# **CAMPSIE MASTERPLAN PLANNING PROPOSAL**

## **Responses to the department's urban design questions**

### Site 3 - Campsie RSL

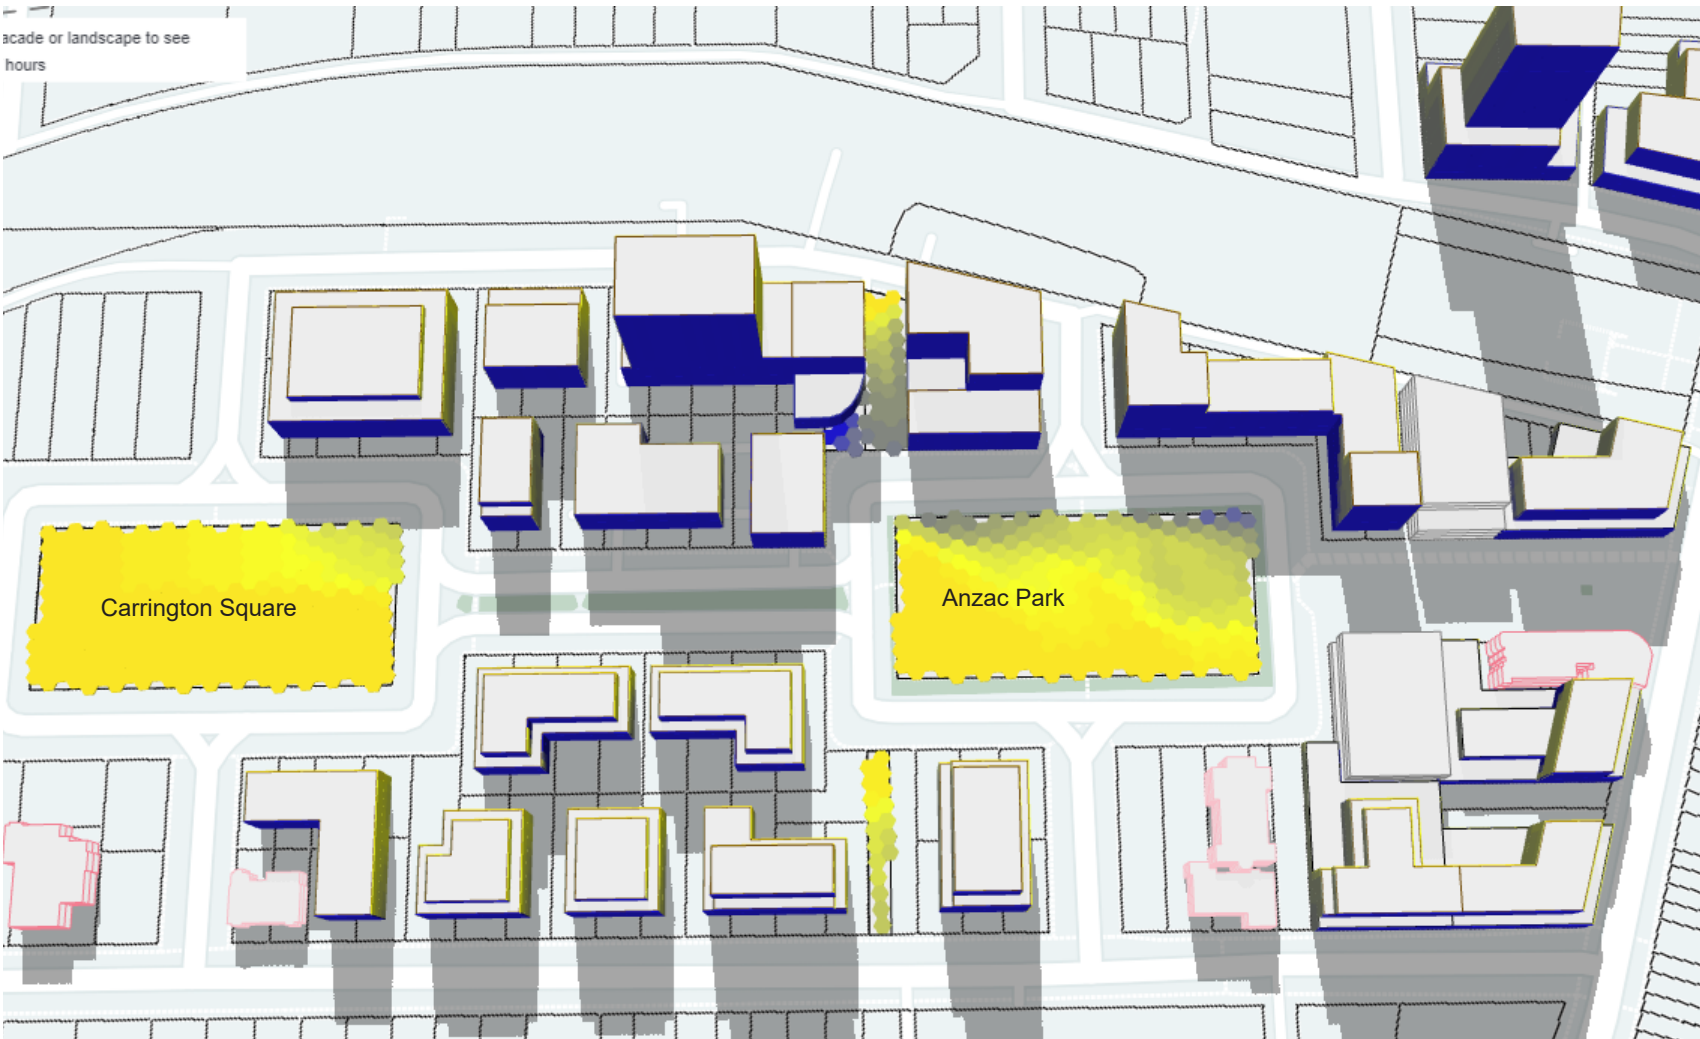
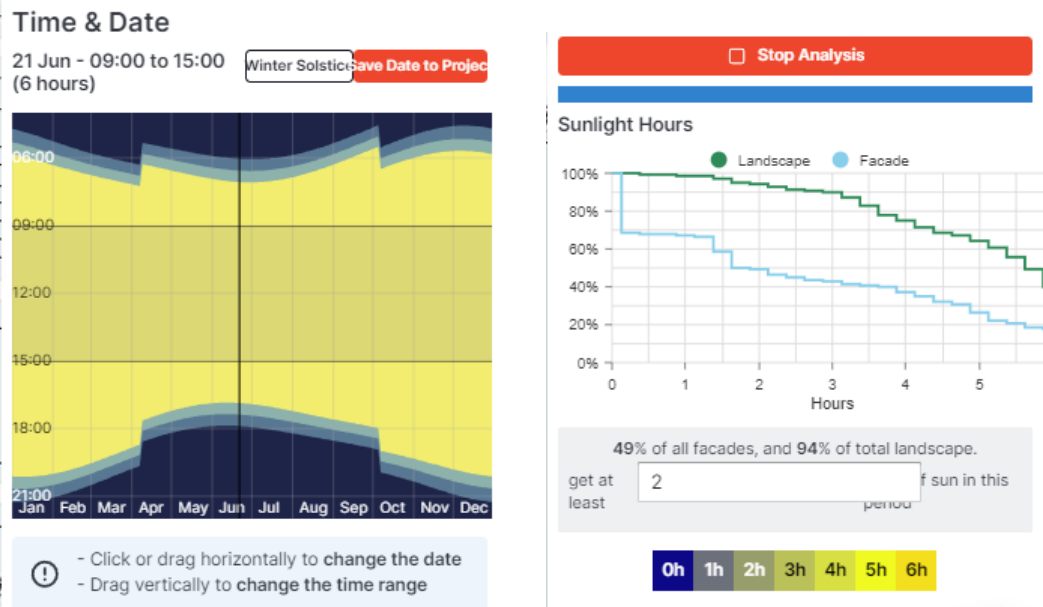
Provide further information to clearly demonstrate the appropriateness of proposed densities and heights to ensure an appropriate level of solar access is provided to:

- i. public open space in mid-winter; and
- ii. neighbouring sites and compliance with SEPP 65 and ADG requirements.

21st june 9am to 3pm:  
94% of total landscape receives at least two hours of sun

### Site 4 - Evaline place updated model

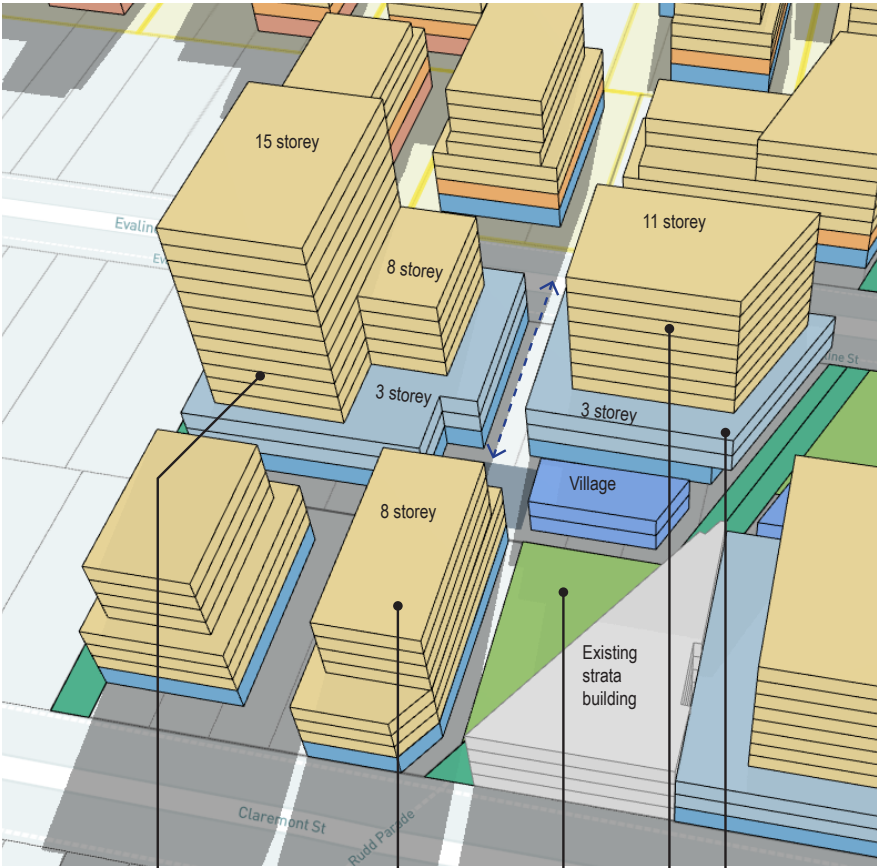
Provide further information to clearly demonstrate the appropriateness of proposed densities and heights to ensure an appropriate level of solar access is provided to:

- i. public open space in mid-winter; and
- ii. neighbouring sites and compliance with SEPP 65 and ADG requirements.

Tower separation distance in excess of ADG requirement to transition of lower scale neighbourhood west.

Change from Panel recommendation to a Regular shaped building to enhance solar aspect to the existing building and public open space.

Reduced tower height to increase afternoon sun exposure to public open space and existing building facade.

Tall tower required west of the site to achieve site FSR while preserving solar performance of public open space and existing residential building.

Public open space shifted south away from the tall towers to the north to increase solar performance in winter.

### Site 4 - Evaline place updated model

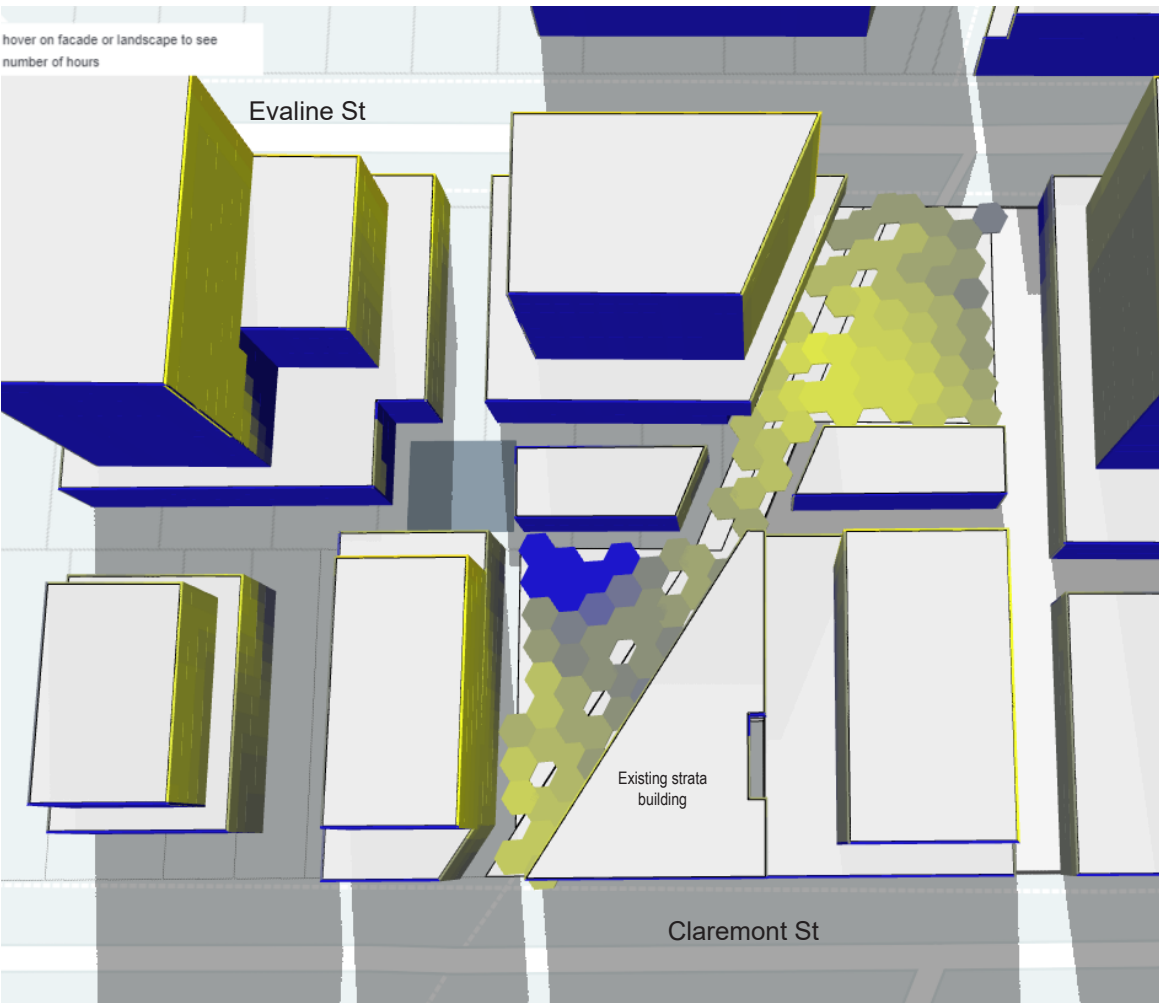
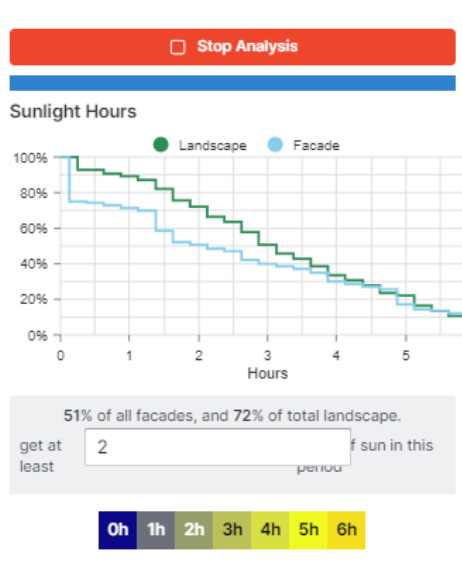
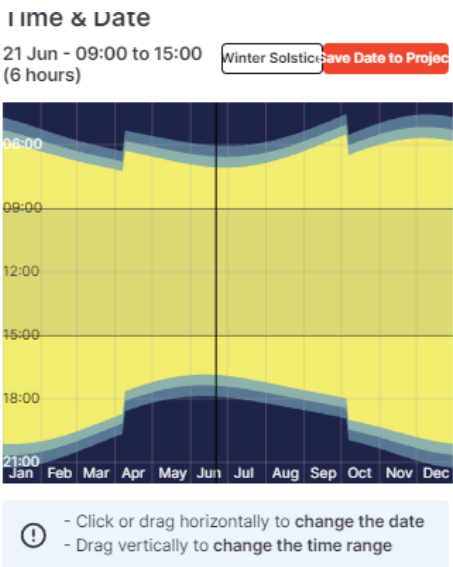
Provide further information to clearly demonstrate the appropriateness of proposed densities and heights to ensure an appropriate level of solar access is provided to:

- i. public open space in mid-winter; and
- ii. neighbouring sites and compliance with SEPP 65 and ADG requirements.

73% of total landscape receives at least two hours of sun

Built form maximise solar access to existing strata building  
(Ground floor commercial and 4 levels of residential)

## 7. GFA Capacity

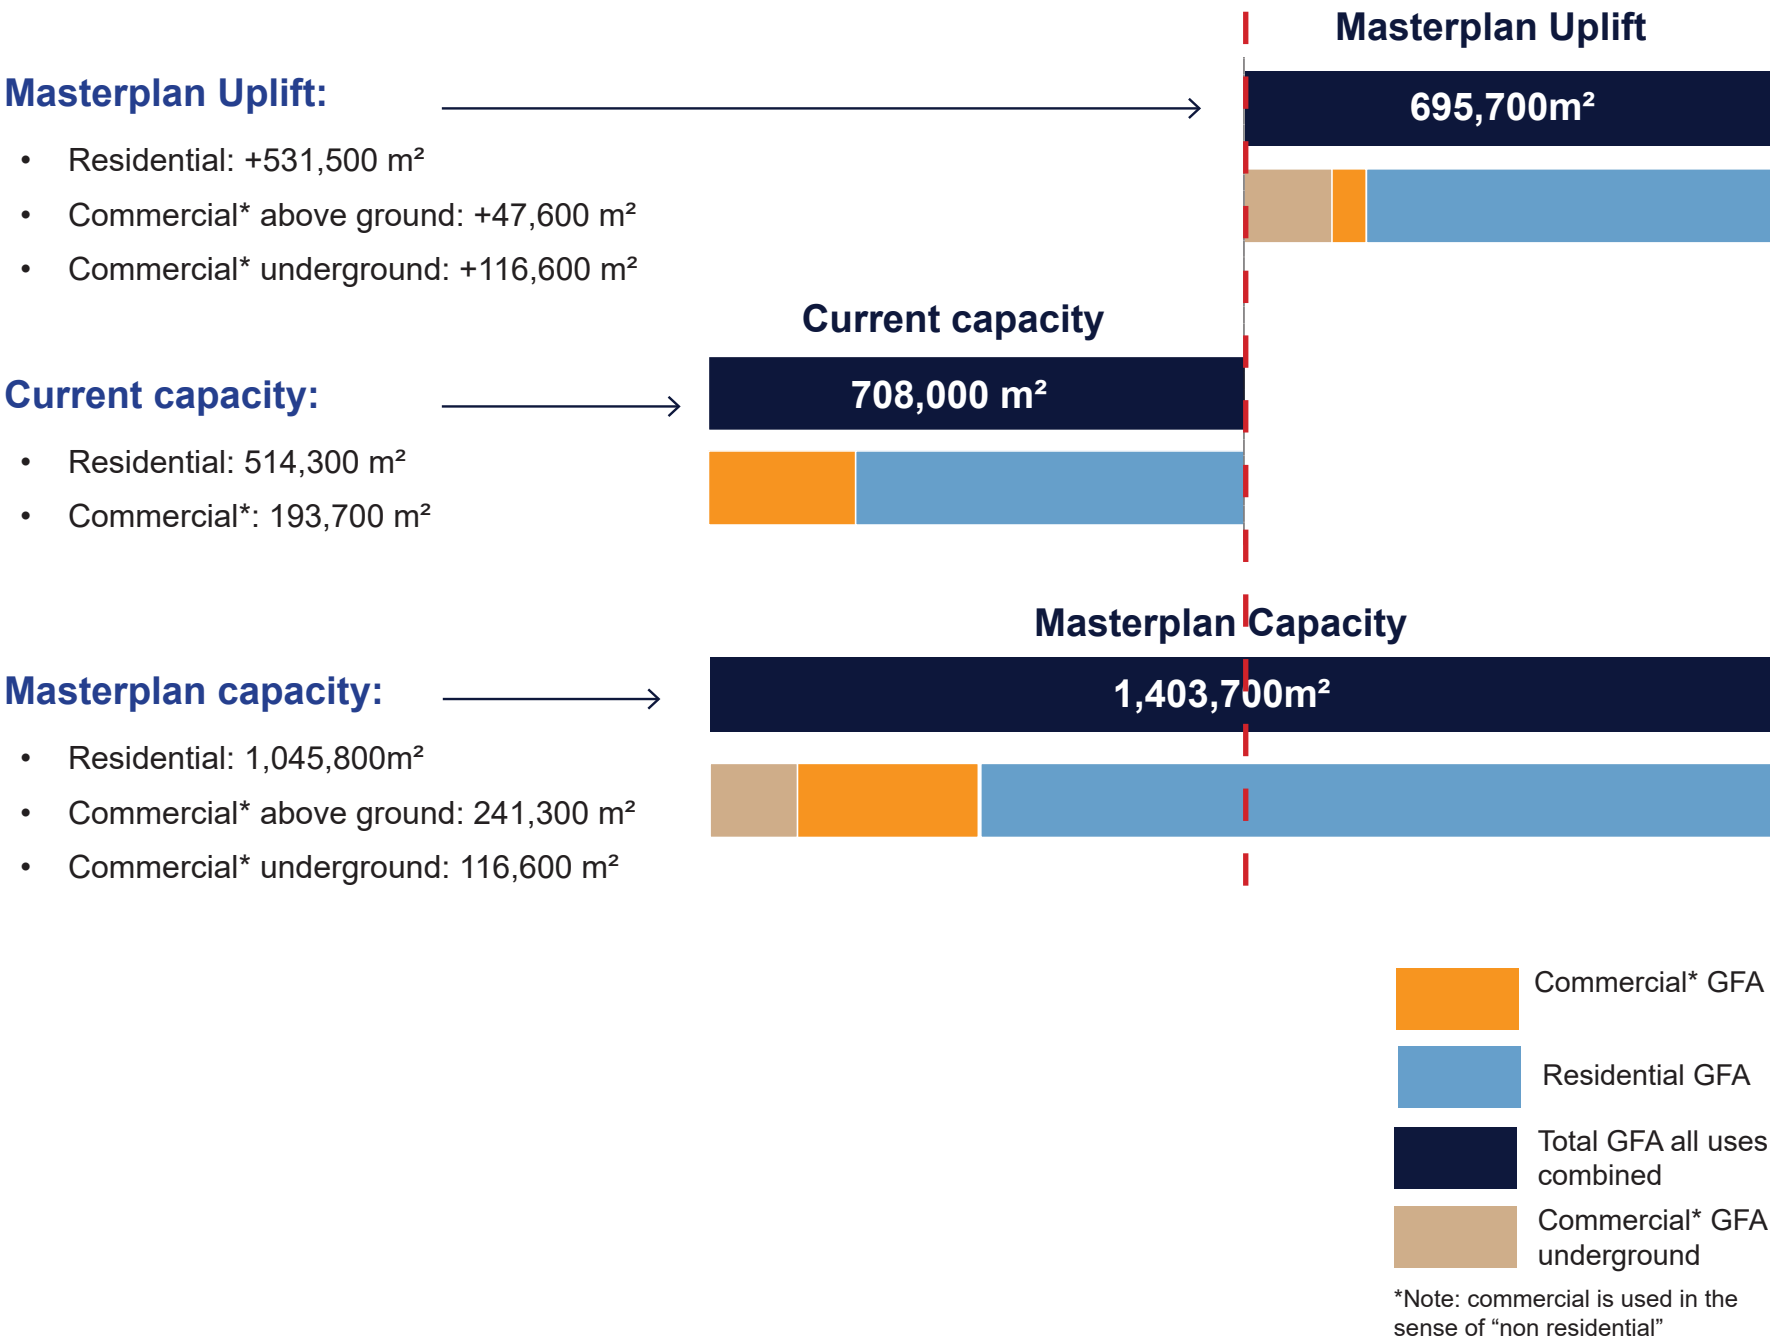
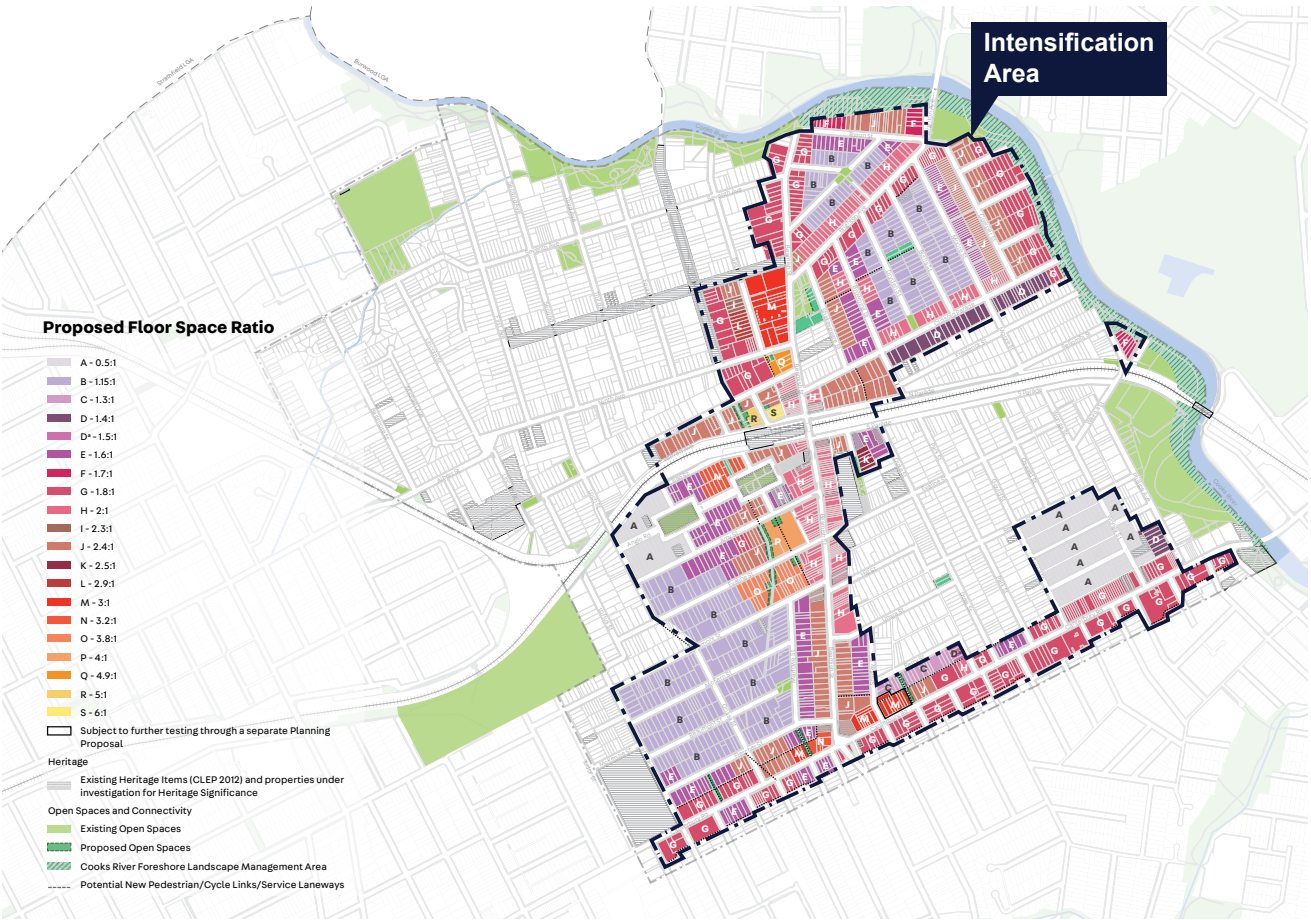
Include an estimate of additional gross floor area expected to be achieved under the proposal, including a likely split of commercial and residential development, explaining the logic for these expected amounts.

The calculation is using the masterplan’s proposed FSR, multiplied by lot size for each property receiving uplift, including the underground FSR bonus in B4 zone.

Shop top housing typologies generally have a commercial ground floor the rest of the building being residential, while mixed-use podium with tower are not easily predictable and the distribution of commercial floorspace can vary. It’s been assumed for this exercise that this category would have a commercial ground floor and a commercial first floor while the rest is residential.

The results are showing that the masterplan proposed control will increase the area capacity by 695,700 m<sup>2</sup>, almost doubling it, with the majority of the additional GFA being dedicated to residential use (+531,500 m<sup>2</sup>).
